Fast Prototyping Board for RA2E2 Microcontroller
Group
FPB-RA2E2
Errata

Renesas RA Family
RA2 Series

2.1 MCU Pin Header J3 Silkscreen

Figure 1. MCU Pin Header J3 Pin 32 Silkscreen Error

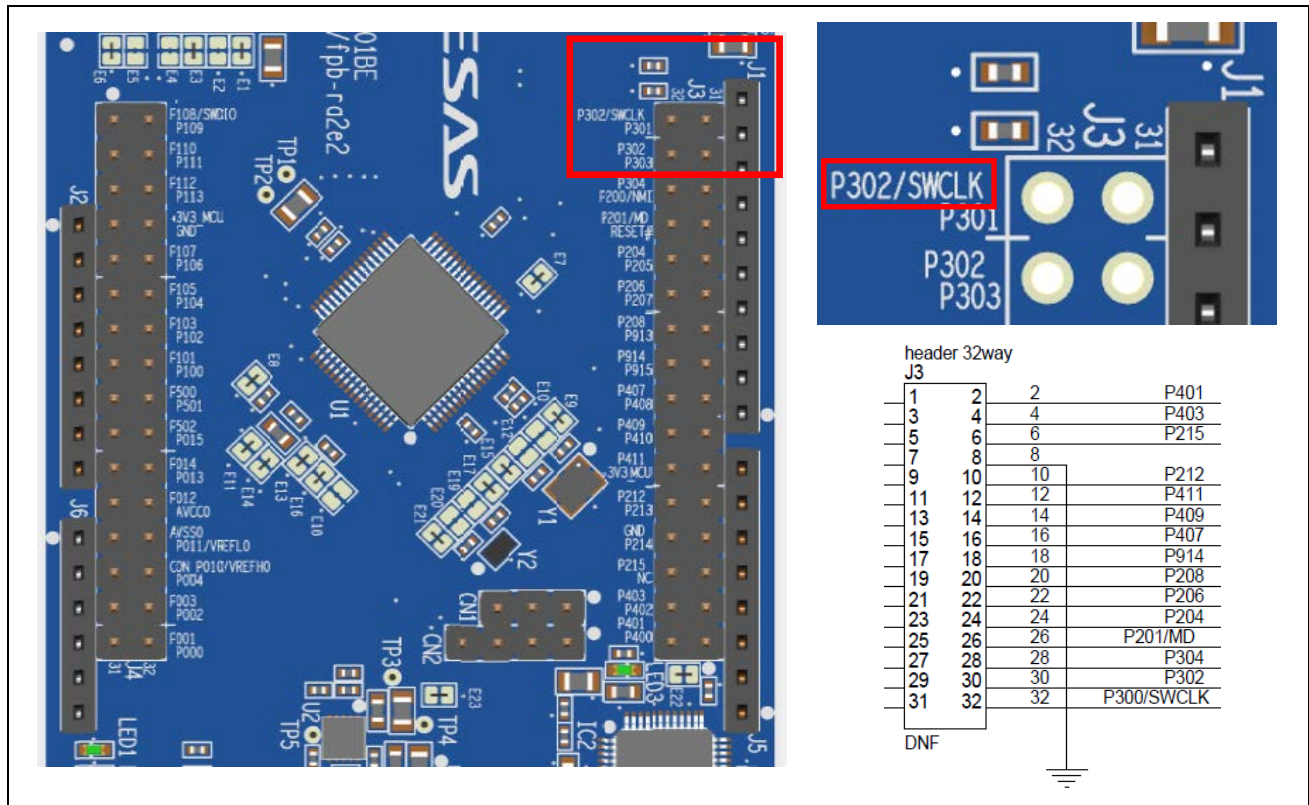
The MCU Pin Header J3 has an incorrect label for pin 32. This is identified as P302/SWCLK when it should be P300/SWCLK. The schematic is correct.

None. The silkscreen has been corrected to show the correct pin identification on later builds of the board.
